MUNICIPAL ENGINEER'S OFFICE.

PLAN OF PROPOSED HOUSE
ON PLOT NO 14 SHEET A26

PLAN
OF PROPOSED BUNGLOW & OUT HOUSES
ON PLOT NO 31 SHEET 17
GARDEN QUARTER
SCALE 8 FT = 1 INCH

PLAN OF PROPOSED HOUSE
ON PLOT NO 123 SHEET A.20

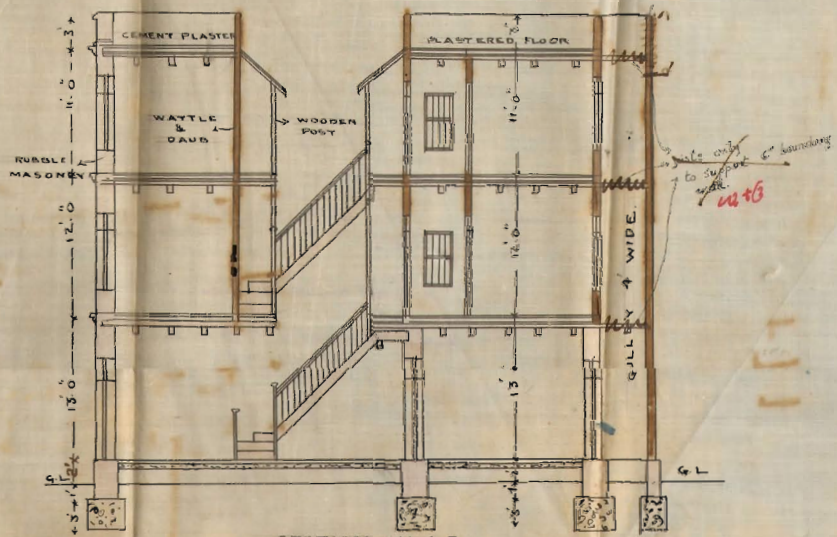
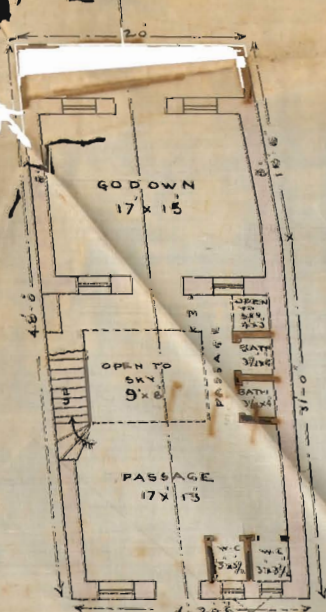
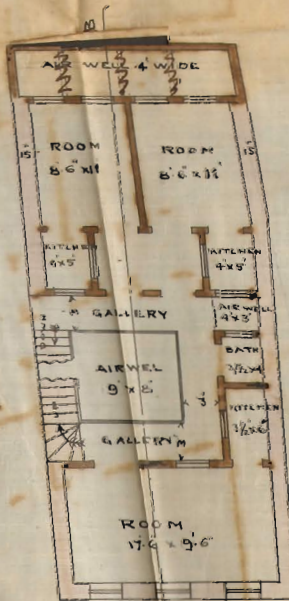
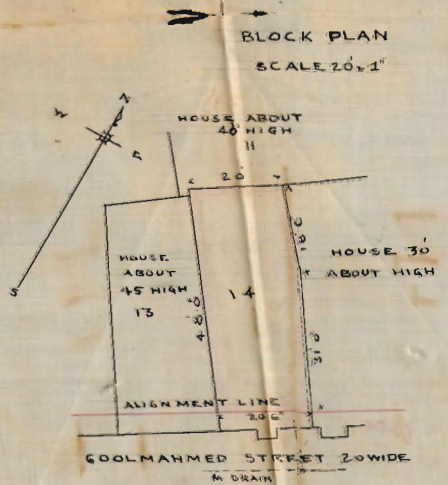
With reference to his application dated 4th instant with a set of plans for building a house on plot No. 14, A-26 Napier Quarter Mr: Visram Umala is informed that atleast 5'-0" width of space must be left for the open gully.

The coverings shown over the open gully on the three floor must be removed.

A pucca wall must be erected on the ground floor at the back of the baths.

I beg to report that the L.C.
beneath the living room is
allowed in several cases. I
don't see why this case not
allowed. As in the 3rd case
it should be kept at least 4 to 5
feet. Respect your order.

*3' fall at the back is inadequate
arrangement for ventilation. The living
room on the 1st floor over the w.c. is
objectionable*

With reference to your Memo No. 6694. dated 17th August ,I beg to return the plan duly amended as required by you. I now believe the same will meet with your approval.

For your information I may tell you that the beams across the gully are merely to support the 6" boundary wall. the spaces between them are left open and so the gully ^{is not covered}. As the wall is 40' high ^{and} I giving these cross beams to support it.

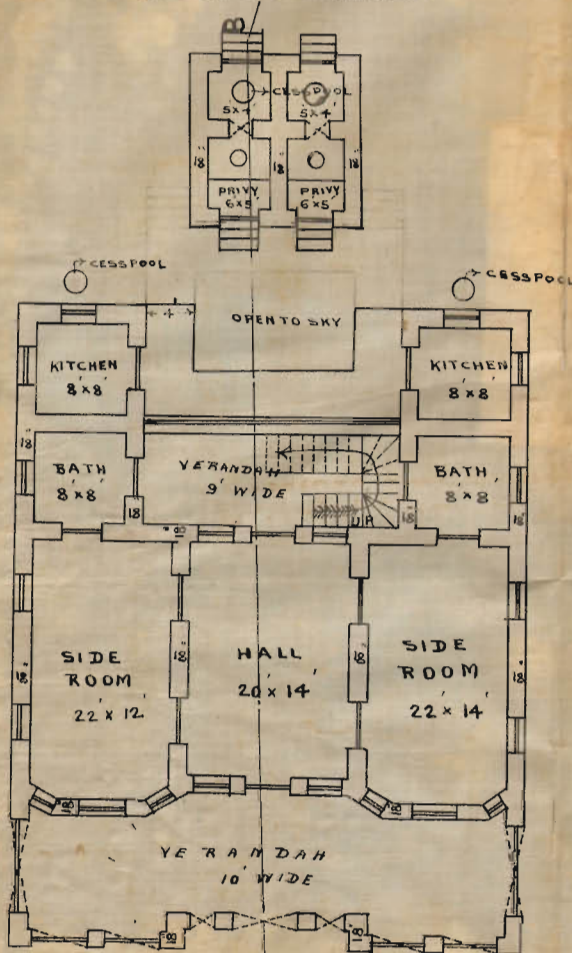
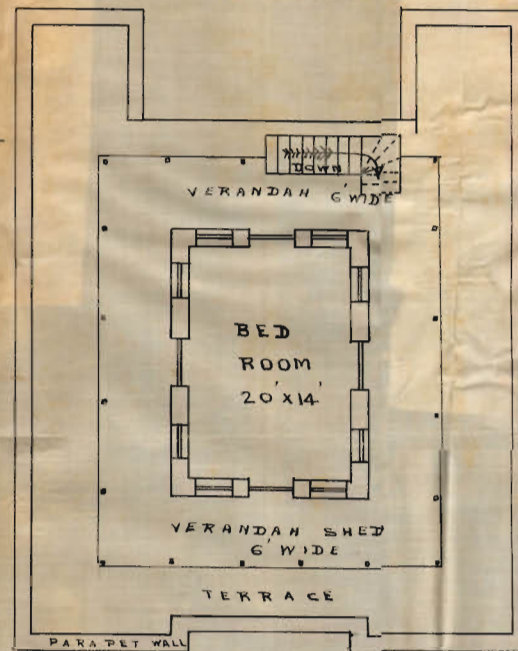
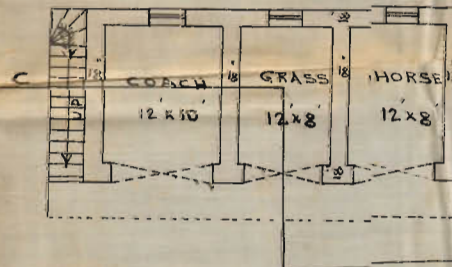
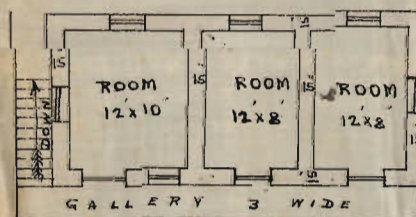
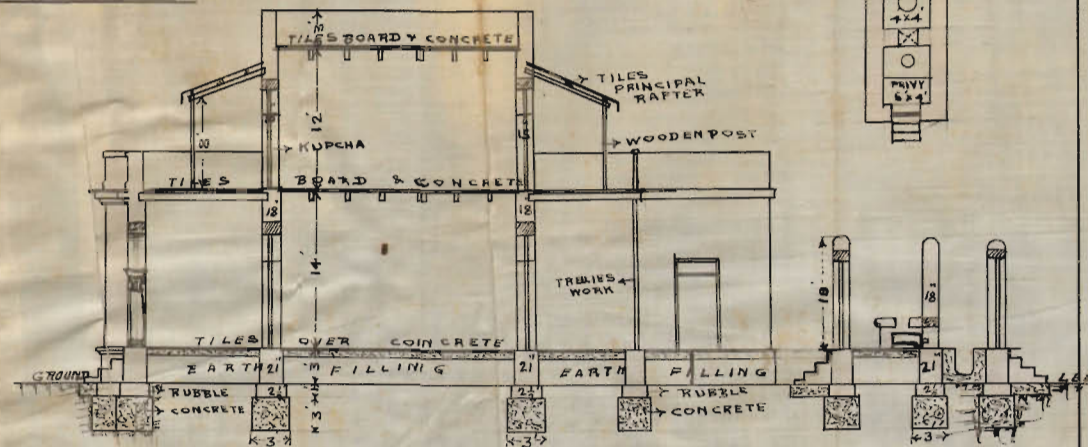
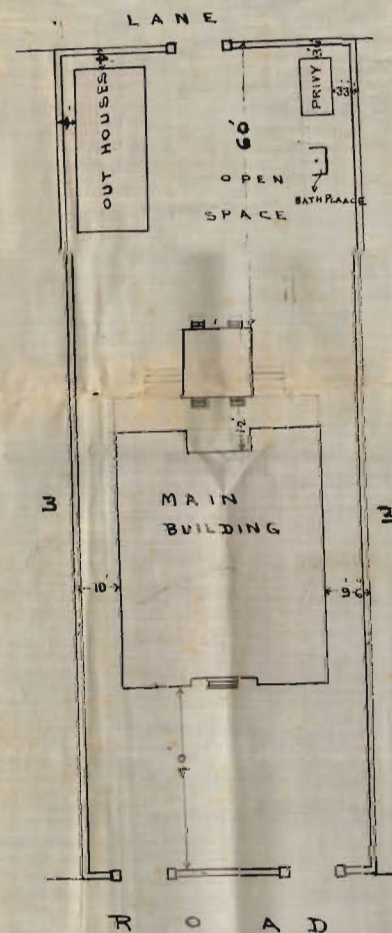
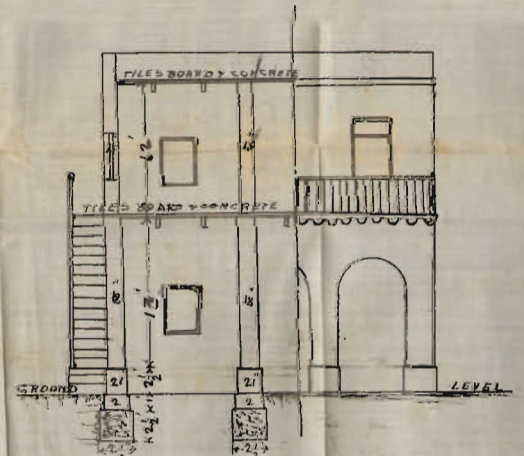
no objection
The applicant should be requested to
have the stable & provide a
catchpit to the same

Enquiry Officer's report Sir, I beg to report that the
out houses only show 11 one foot and frame
the compound wall. Section does not show how
the people get to the premises. Request your order.
 Date 1915 Enquiry Officer.

outhouse opening must be set back at least
3'6" from the compound wall.

- 1, Out-houses and privy must be set back at least 3'-0" from the compound wall as the present space is not sufficient for sanitary requirements.
2. Bath room must be provided for the out-houses.
3. Block plan to be corrected as the dimensions shown therein do not seem to be correct.

Back rooms for authors not
provided. Block plan in-
correct.

1. Out- houses and privy are already shown 3' away
from the compound wall. The dimension shown was 4' including
1' compound wall.

2. A bath place has been provided for servants.

3. Regarding block plan all of the dimensions are
shown correct.

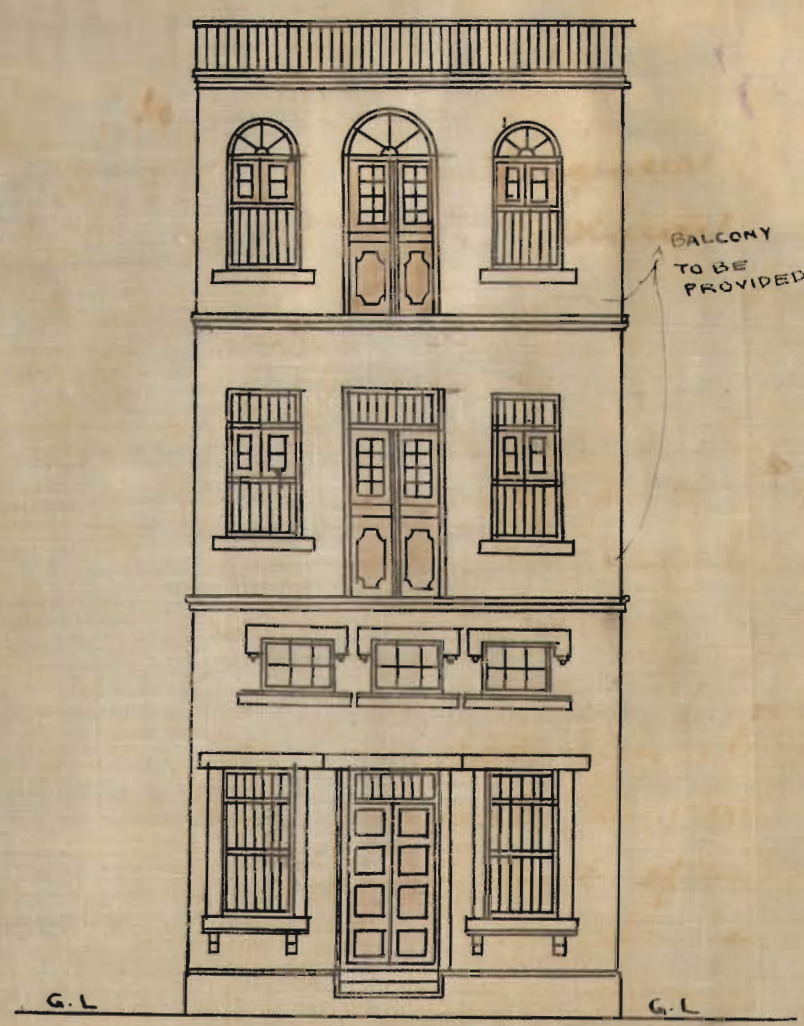
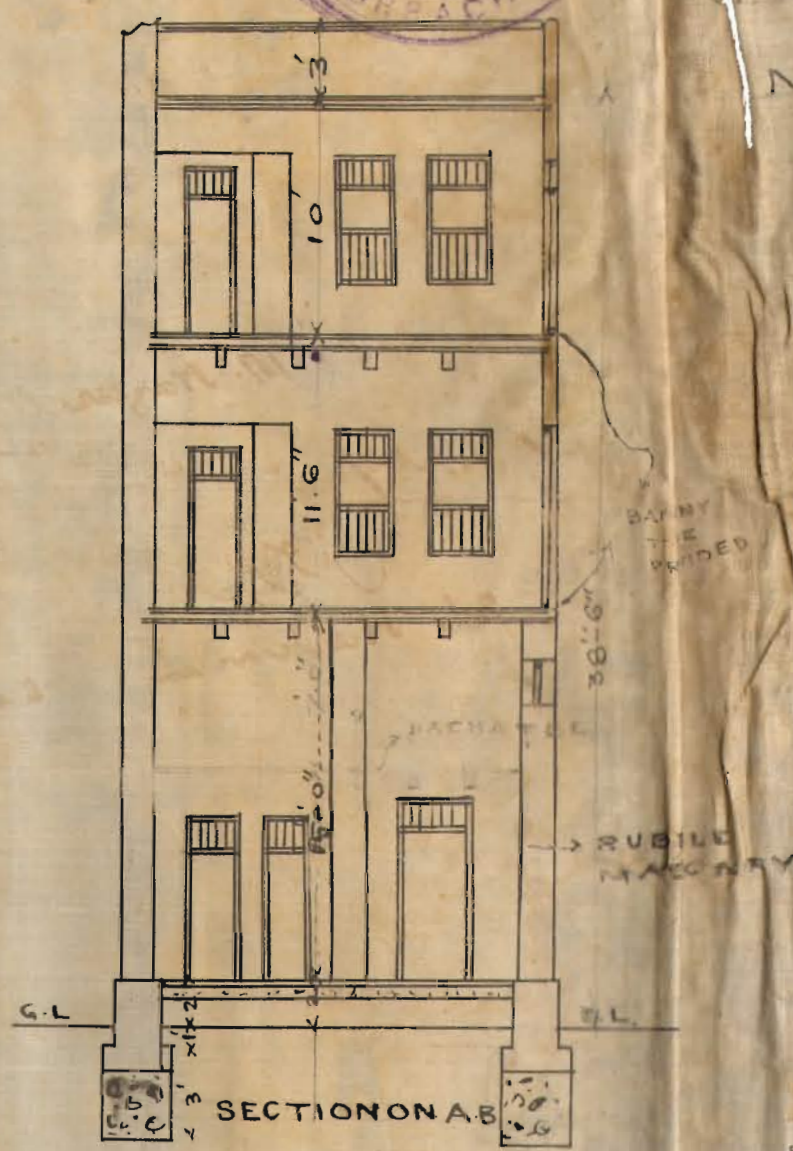
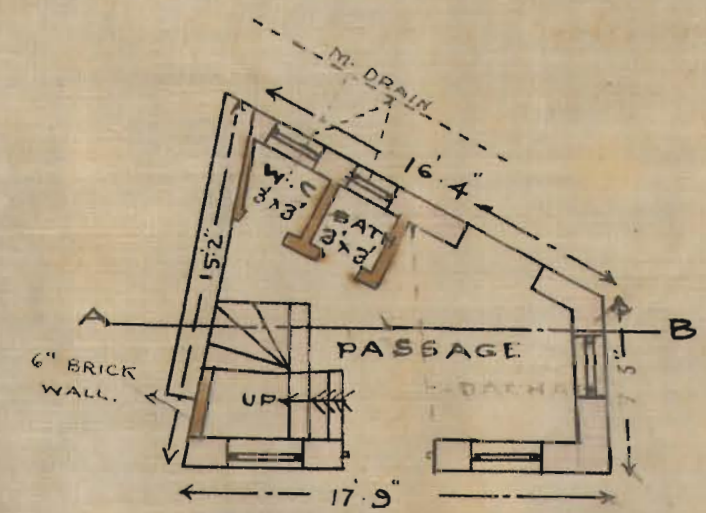
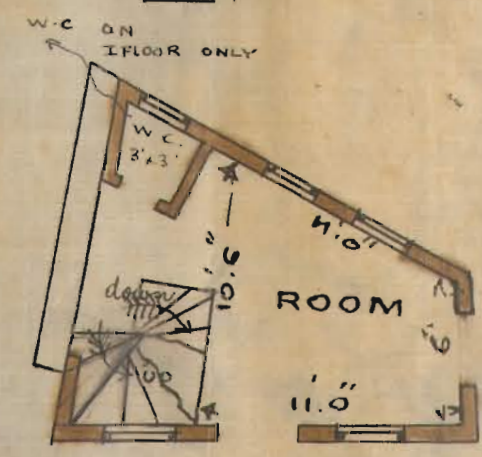
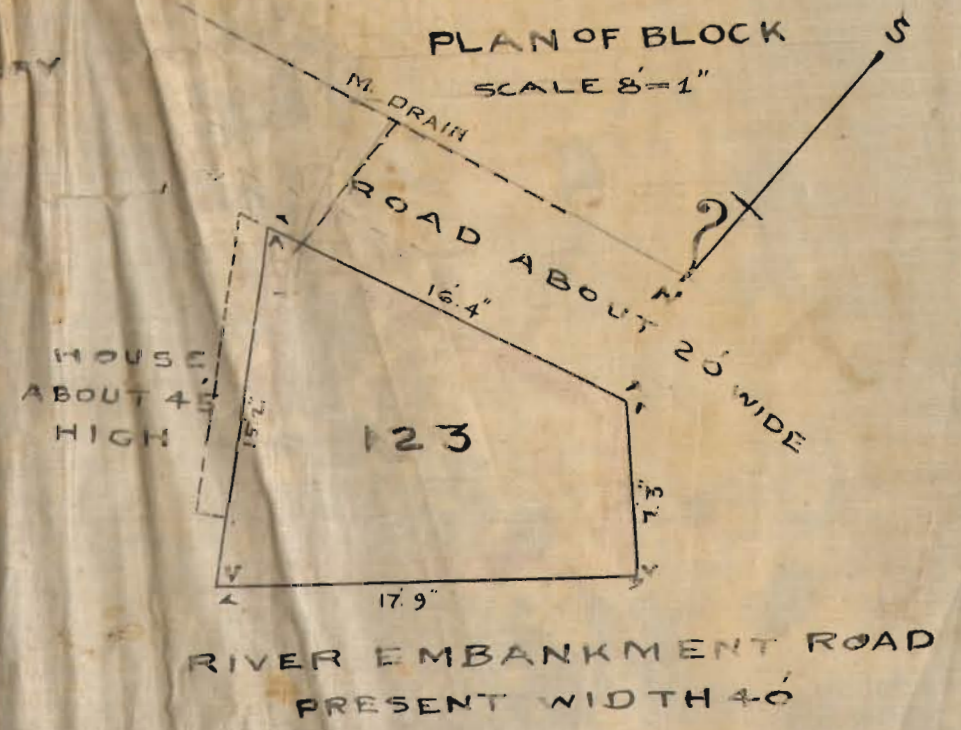
With ref. to his application of "Current
with a set of plans for bldg. house on plot
no. 123 A20. Mr. Harwood Purmurel is
informed that the Section shown therein
can not be allowed - He is requested to
explain how he proposes to support the bldg.
on the east side without any wall. The
plans can not be approved & are returned
herewith for amendment.

With reference to his application dated 11th ultimo with a set of plans for building house on plot No. 123 A 20 ^{Nagar Quarter} Mr: Harumal Pursomal is informed that the Duchatis shown therein cannot be allowed. He is requested to explain how he proposes to support the building on the east side without any wall. The plans cannot be approved and are returned herewith for amendment.

With reference to your No. E. 7220 of 4th Sept. 15, addressed to Mr. Harunul Parsumul I have the honour to return herewith the plans for a house on Plot No. 123, A 20, Napier Quarter with the dachatie deleted as required.

No wall is put on the east as there is an existing wall of adjoining owner as shown in full line on plan & in dotted line on site plan. The portion projecting beyond the adjoining house will be walled in by 6" brick wall. The beams will rest on the North & South walls and no weight will come on the east wall.
